ADDENDUM #2

CITY HALL ELECTRICAL UPGRADE

BID #13/14-003 – PWP# WA-2013-292

3 PARTITION WALL DETAIL
SCALE: NTS

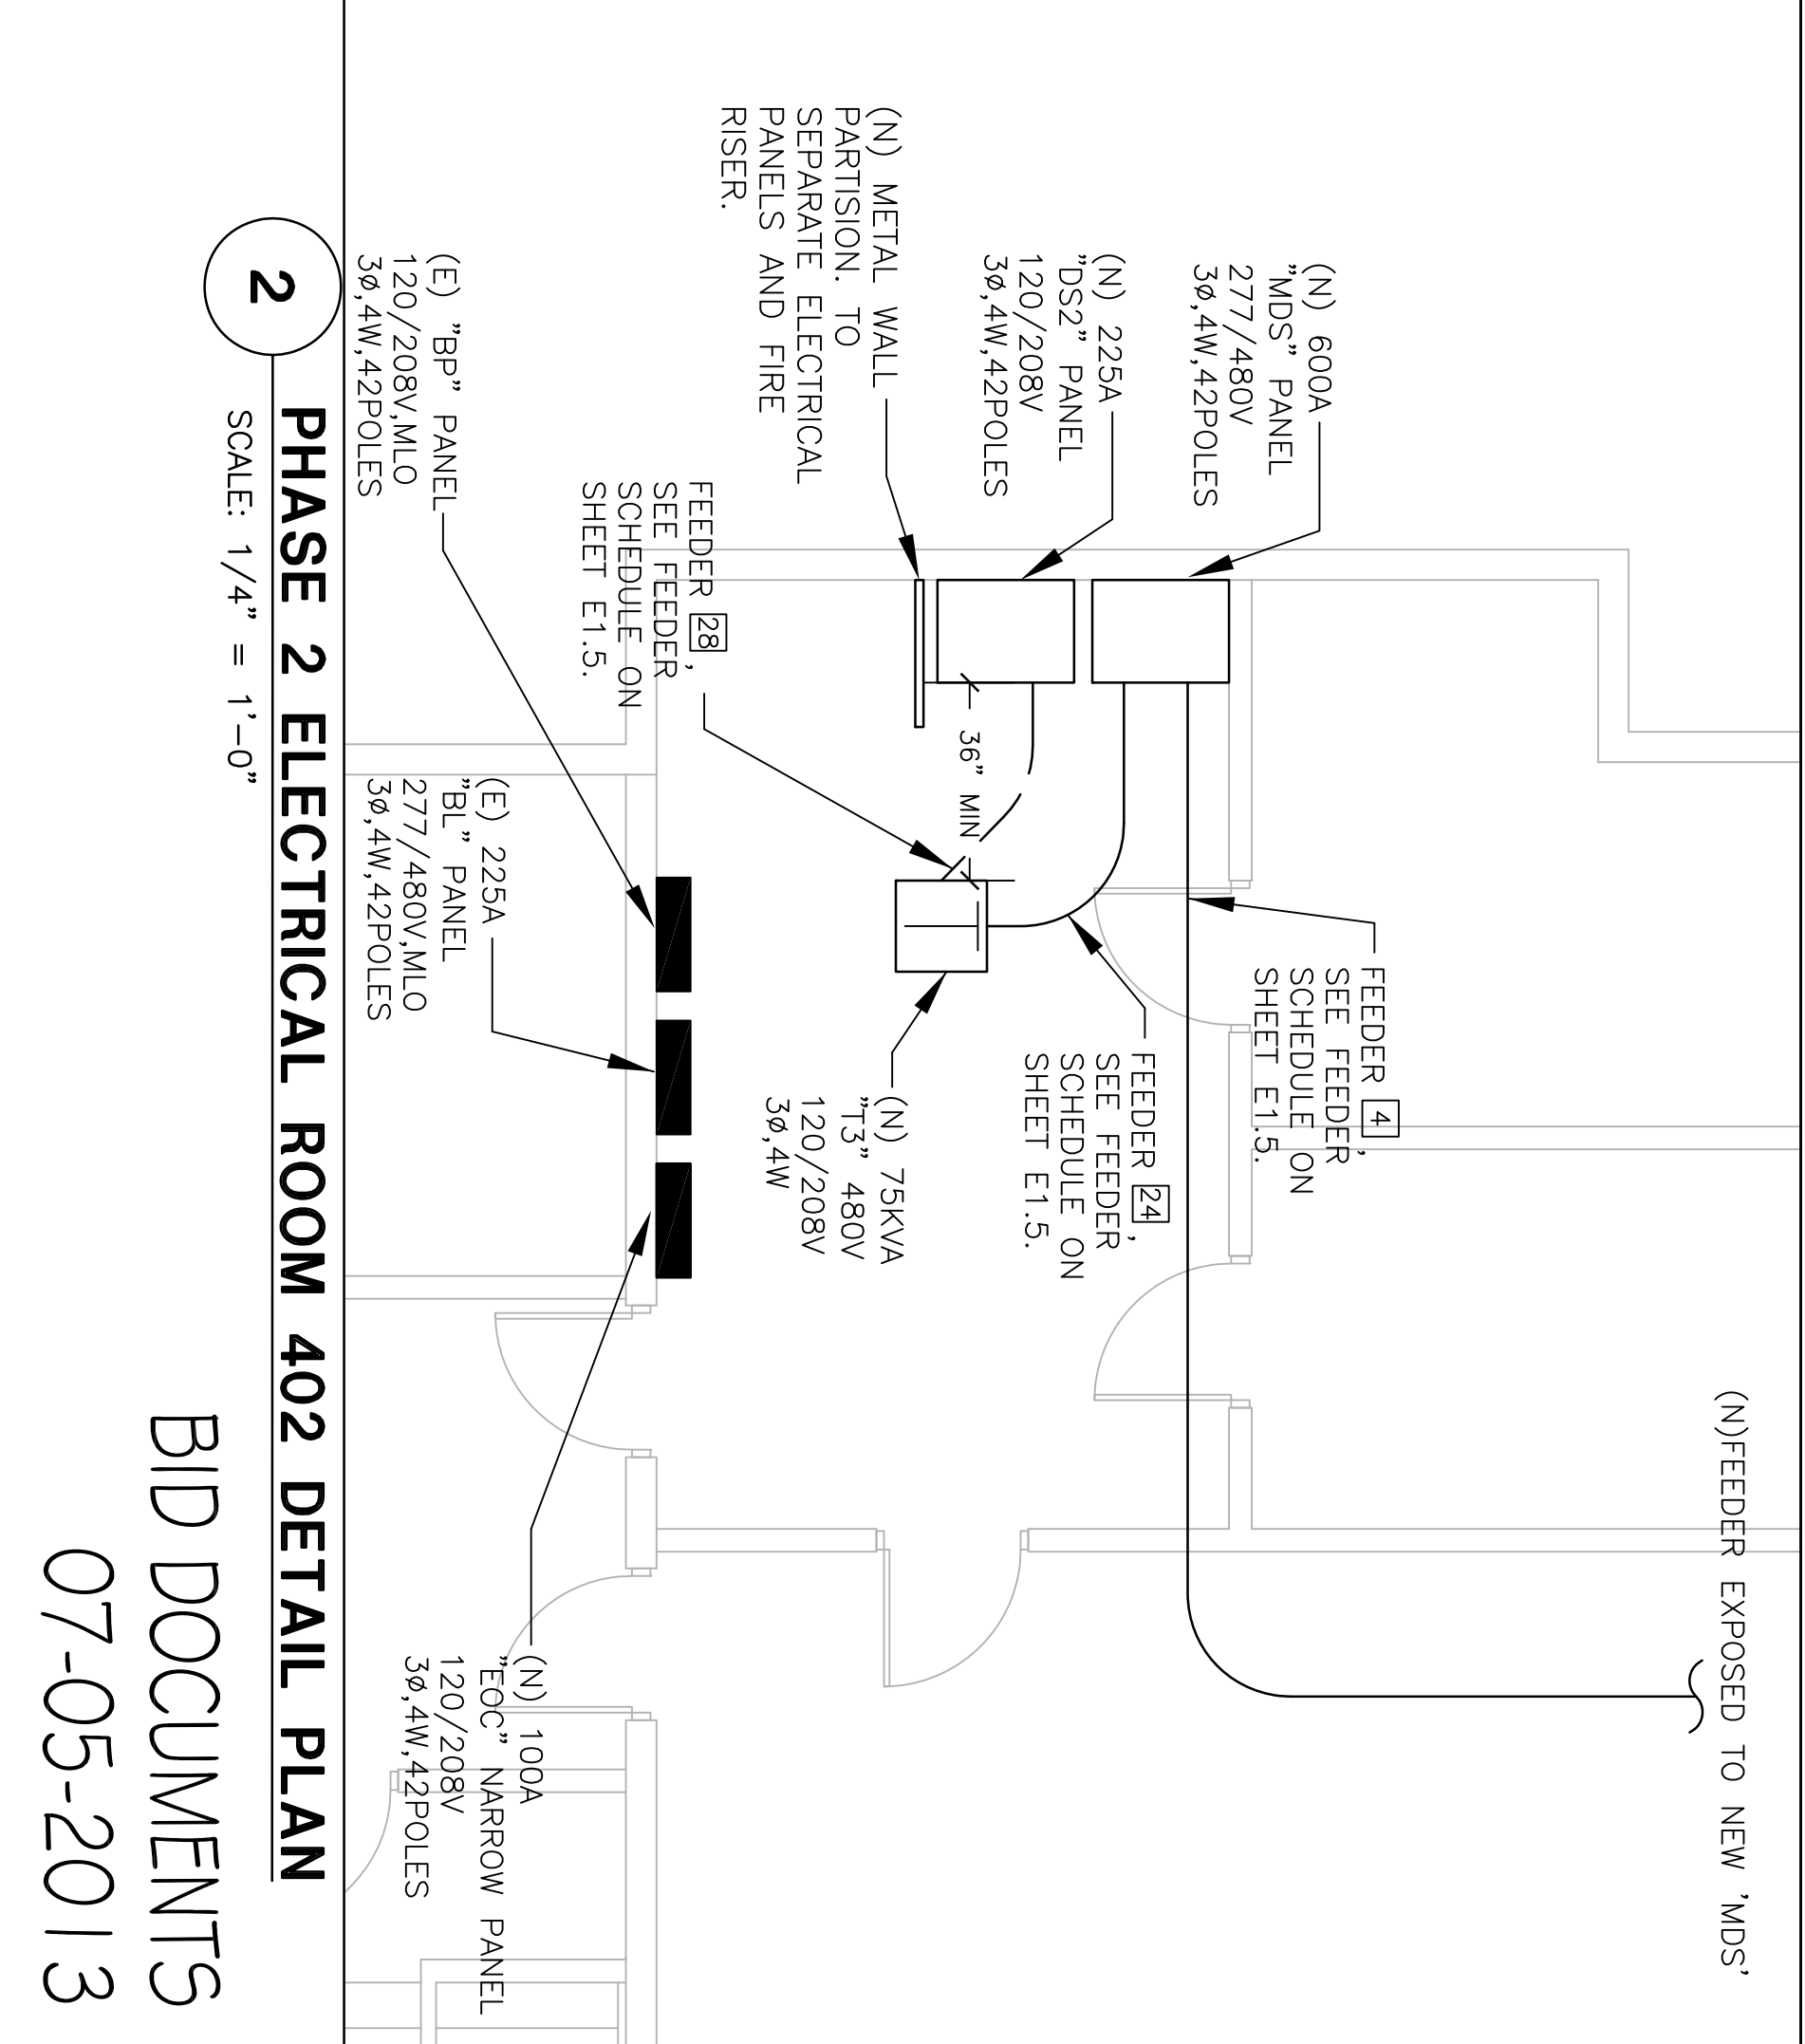
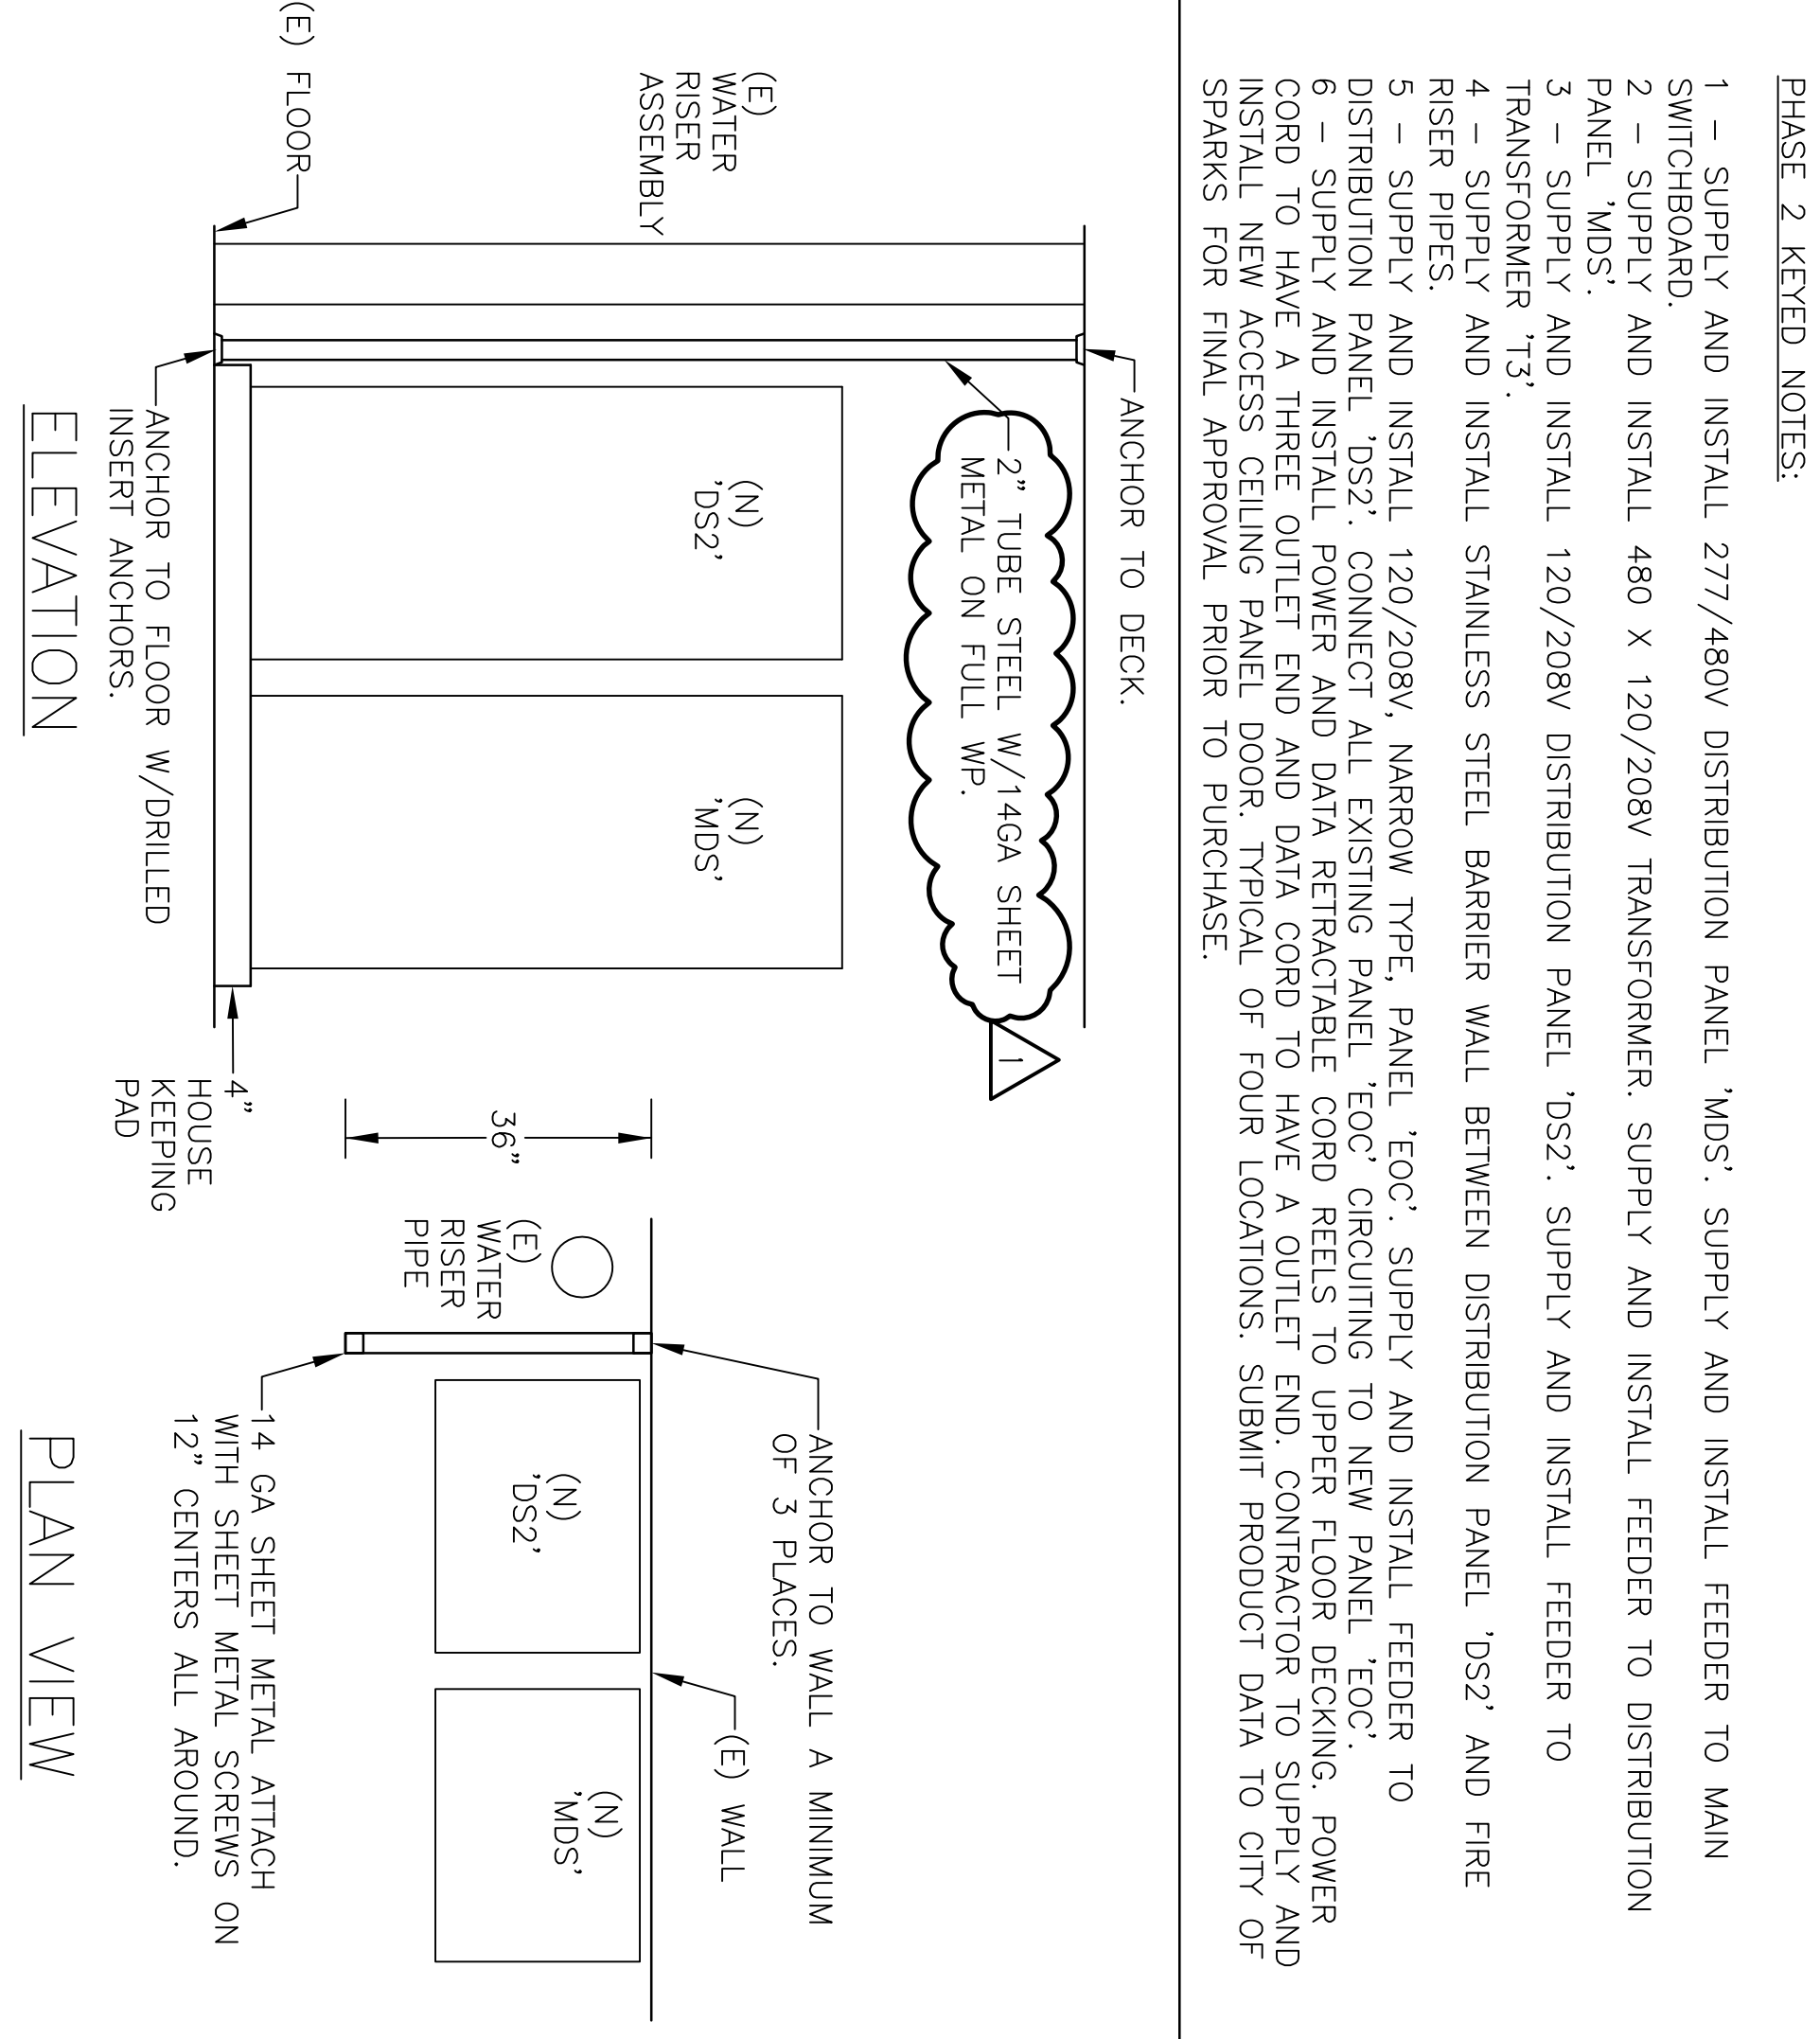
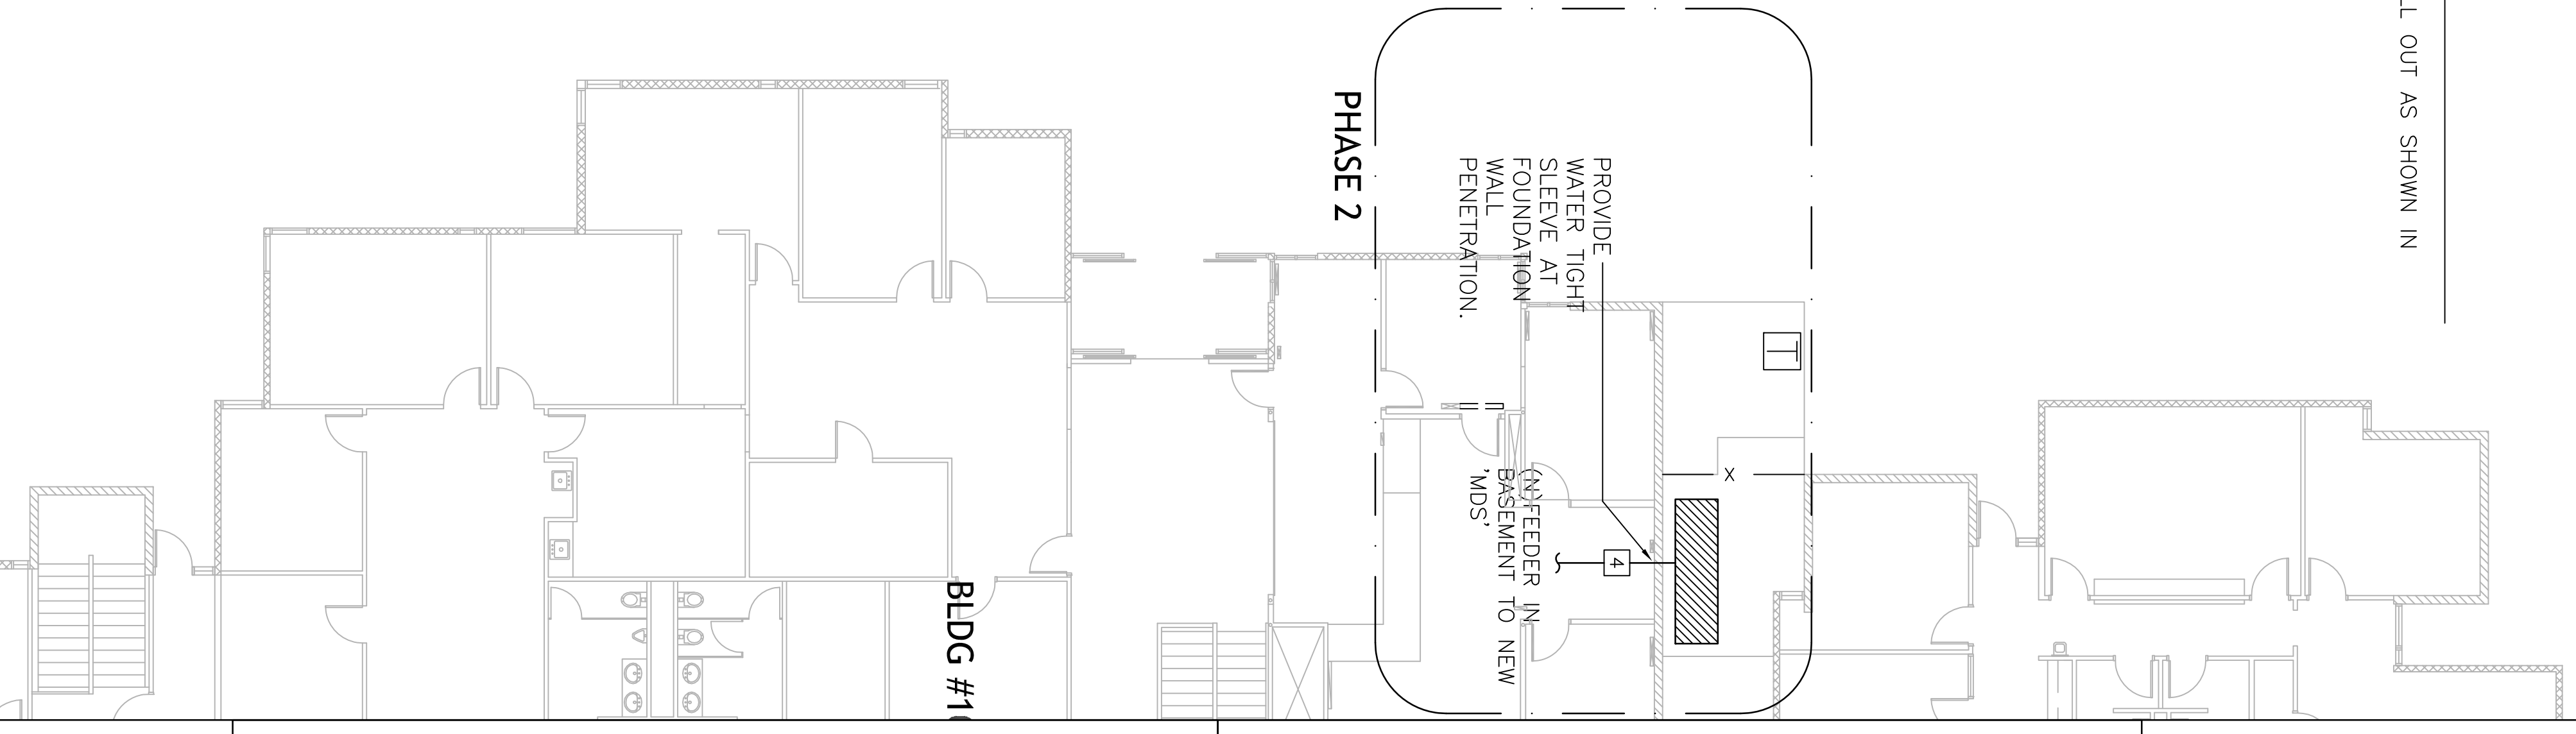
d) **Where to locate the sprinkler system storage box located in the basement electrical room adjacent to where the fire sprinkler risers are located.**

- c) E3.1: Deleted second background to clean up plans.
- d) E3.2: Changed panel '2HA' size to match single line diagram. The panel should be a 200 amp panel. Panel '4HA', transformer 'T4', and panel '4A' were corrected to reflect the correct location.
- e) E3.4: Clarified partition wall is to be constructed using sheet metal.

Answer: The sprinkler system storage box shall be relocated on the water riser pipe side of the new partition wall that is shown on sheet E3.4. The new location shall be approved by the City of Sparks.
